CREAKING NOISE ON SIDE OF CONVERTIBLE TOP NEAR CENTER/FRONT

F23 (2 Series Convertible)

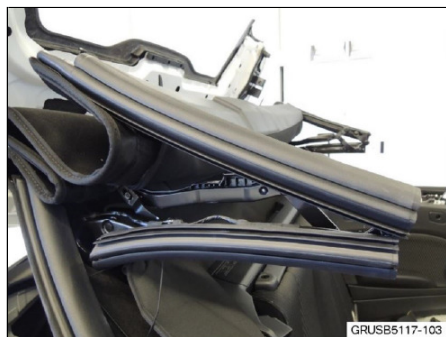
Friction between convertible seal and the windshield or side window.
